## PLAT COMMITTEE

<b>Case Number:</b>	2024-PLT-031
<b>Property Address:</b>	7125 Wellingshire Boulevard ( <i>Approximate Address</i> )
<b>Location:</b>	Perry Township, Council District #22
<b>Petitioner:</b>	Wellingshire Partners LLC, by Brady Kuhn
<b>Zoning:</b>	D-P (FF)
<b>Request:</b>	Approval of a Subdivision Plat to be known as Southern Dunes Commons at Wellingshire, subdividing 18.73 acres into two lots and three blocks, with a waiver of sidewalk requirements along Southport Road, per Chapter 741, Article III, Section 6 of the Consolidated Zoning and Subdivision Ordinance.
<b>Waivers Requested:</b>	Sidewalk Waiver (partial, along Southport Road)
<b>Current Land Use:</b>	Undeveloped
<b>Staff Reviewer:</b>	Michael Weigel, Senior Planner

**2024PLT031 ; Proposed Plat**

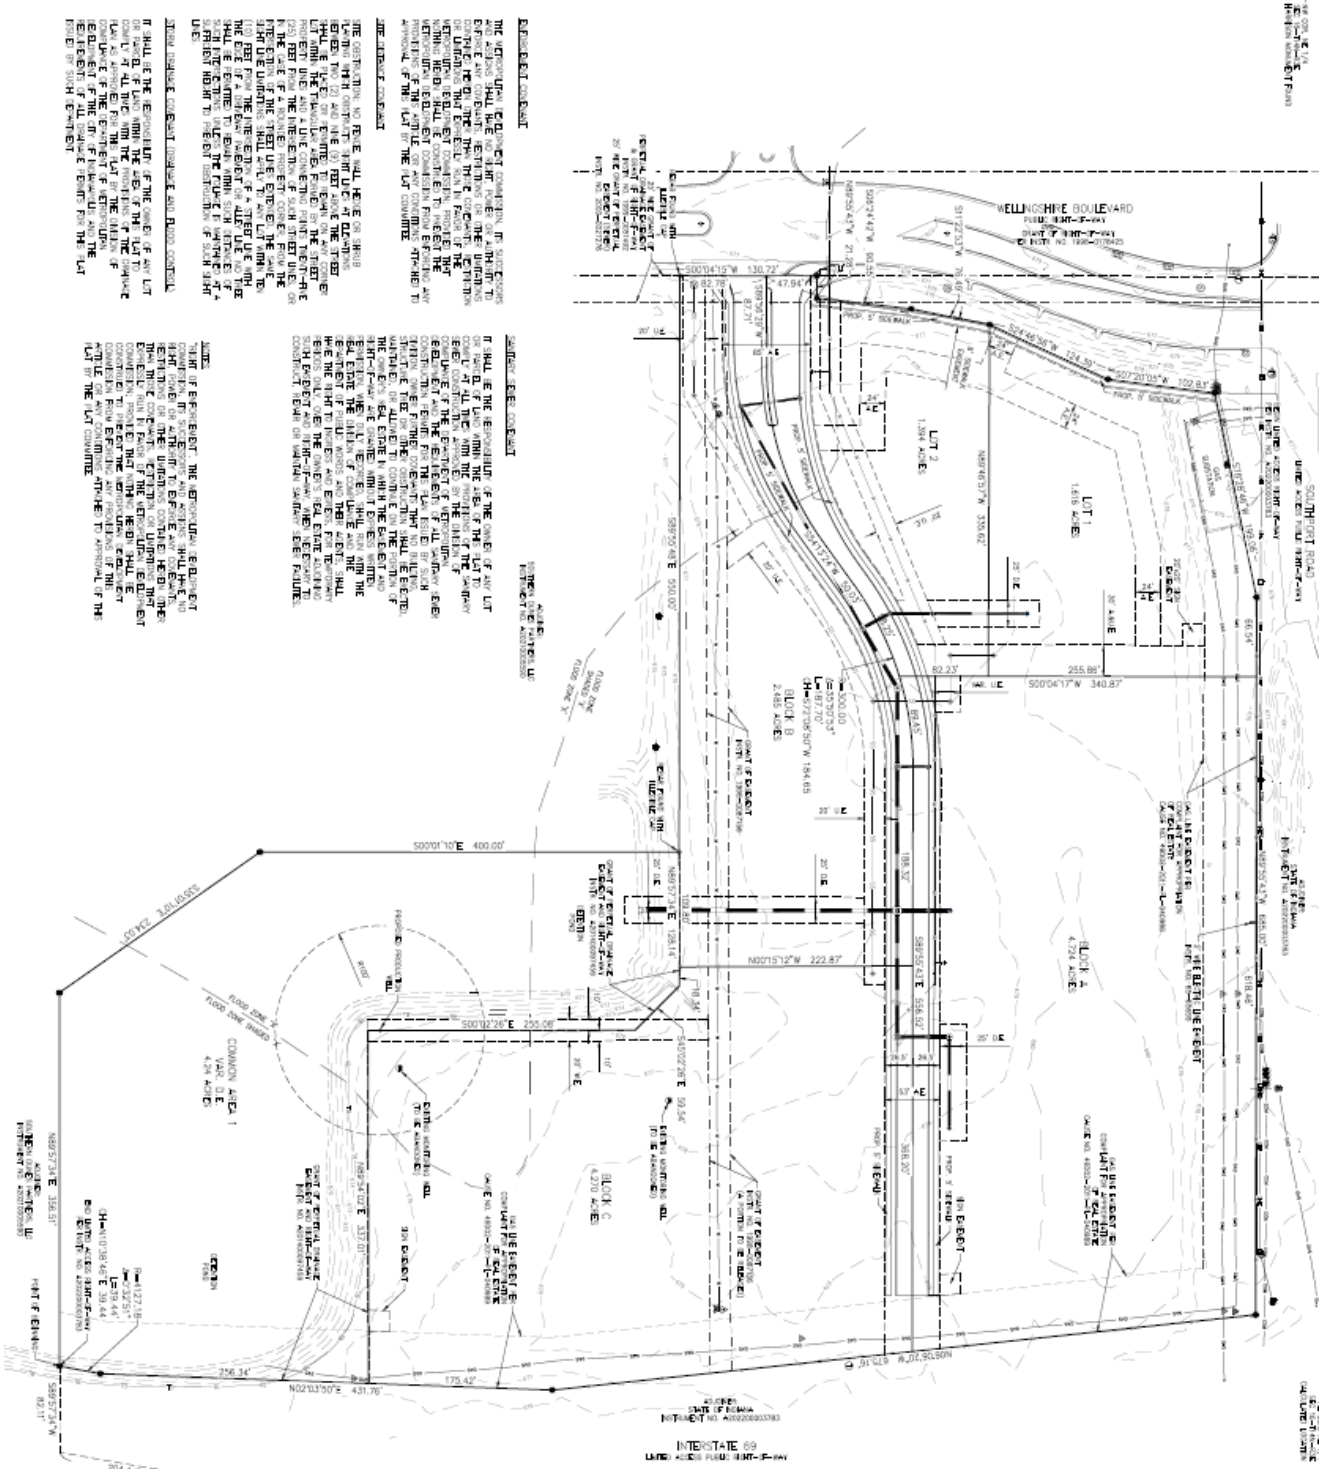
Staff recommends that the Plat Committee **approve** and find that the plat, file-dated May 2, 2024, complies with the standards of the Subdivision regulations, subject to the following conditions:

12. That the sidewalk waiver request be approved on the condition that pedestrian crosswalks and infrastructure are added across the southern and eastern legs of the intersection of Southport Road and Wellingshire Boulevard by the petitioner (subject to INDOT or DPW approval).

Sidewalk is either existing or proposed along Wellingshire Boulevard and would not be required along the eastern portion of the site near the interstate. The petitioner has requested a waiver of sidewalk requirements for the portion of the plat bordering Southport Road to the north (approximately 885’ in length) due to what they identify as uneven grading, separation from Southport Road, and a lack of need due to interstate proximity and the placement of sidewalks along the proposed access road.

Both sides of Southport Road to the west of the subject site have sidewalks installed, as well as both sides of Wellingshire Boulevard (upon approval of the plat) and one side of Belmont Avenue to the northwest. No dramatic change in grade was noticed along the potential sidewalk area, and staff believes that increased pedestrian access to future businesses at the site would benefit both property owners and nearby residents. Sufficient evidence was not provided to justify the waiver, and staff recommends denial of the request. If the plat committee approves the waiver against staff’s recommendation, a contribution in lieu of sidewalk installation should be required as a condition of approval subject to Section 744-301.G.
